City of Richmond
Planning and Development Division

Report to Committee

Re: **Application by Matthew Cheng Architect for Rezoning at 9071 & 9091 Williams Road from Single-Family Housing District, Subdivision Area E (R1/E) to Townhouse District (R2 - 0.6)**

RZ 05-308086

Sheet No.
 SITE PLAN
 PROJECT DATA

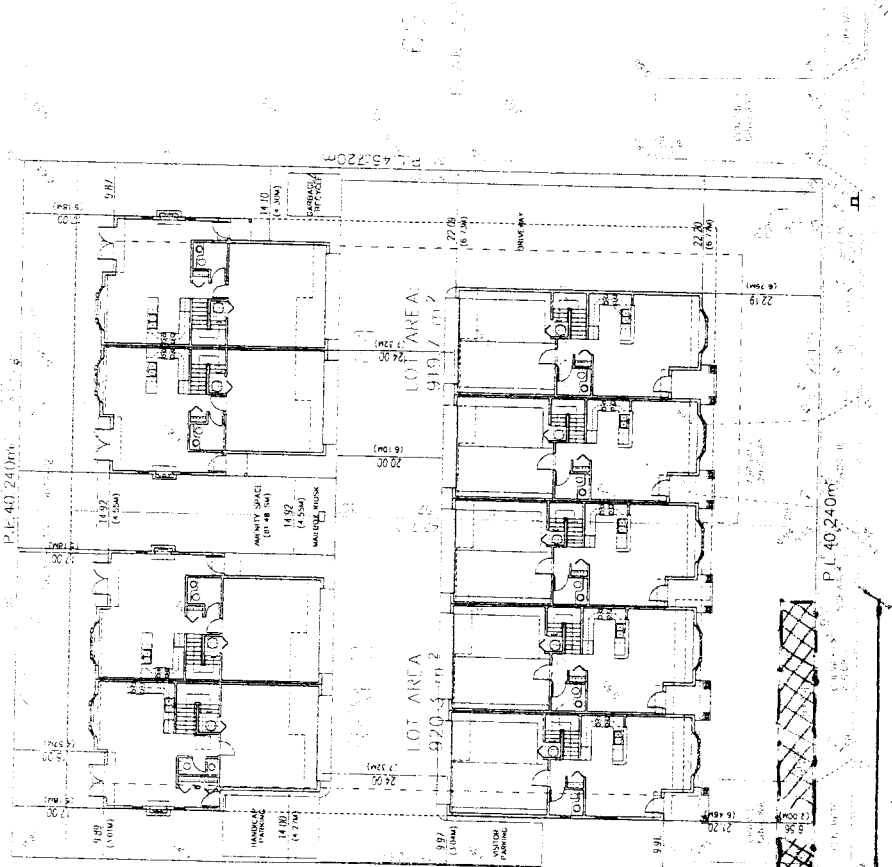
Setbacks are maintained at 6m (19.68 ft.) for a majority of the Williams Road fronting units (except for the westerly two units) and 3m (9.84 ft.) along the side yards. The rear yard setback is maintained at 4.5m (refer to **Attachment 2** for a copy of preliminary site plan and building elevations).

- A 2m (6.56 ft.) wide strip of land (measuring 15.74m (51.64 ft.) in length from the subject sites west property line) across a portion of the site's Williams Road frontage is being dedicated in order to enable the possibility of implementing future intersection improvements at Garden City Road and Williams Road.

One driveway is proposed along the east edge of the site and is located to avoid potential conflicts arising from the close proximity to Garden City Road/Williams Road intersection. The long-term objective is for the driveway access established on Williams Road to be utilized by adjacent properties if they ultimately apply to redevelop. A cross access easement will be secured as a condition of rezoning to facilitate this.

- Articulation of building elevations through architectural refinement and cladding treatments.
- Implementation of appropriate number of replacement trees.
- Overall site landscaping, which is to include "hard" landscape treatments (i.e., permeable pavers, stamped concrete, walkways, benches and play structures).
- Conditions of adjacency to surrounding land uses (i.e., single-family dwellings).
- Review of requested variances (based on current drawings submitted at rezoning):
 - Reduce front yard setback from 6m (19.68 ft.) to 4.76m (15.62 ft.) for the west portion of the building due to the required 2m (6.56 ft.) dedication along Williams Road.
 - Increase the lot coverage from 40% to 43% - Requested as a result of predominant 2 storey massing over the site with limited half storey elements for the dwellings along Williams Road.

1. Consolidation of 9091 & 9071 Williams Road into 1 development parcel.
2. 2m dedication along the Williams Road frontage for 9071 Williams Road. The 2m dedication is 15.74m in length measured from the subject sites west property line.

3. Registration of a cross access easement along the subject sites internal drive-aisle and driveway access to Williams Road enabling access to/from the site for neighbouring properties to the east and west and potentially consolidated lots. Cross access shall be granted in favour of 9940 Garden City Road and 9031/9035 & 9051 Williams Road (or any land assembly thereof) along with 9111 Williams Road (or any land assembly thereof) to the east.
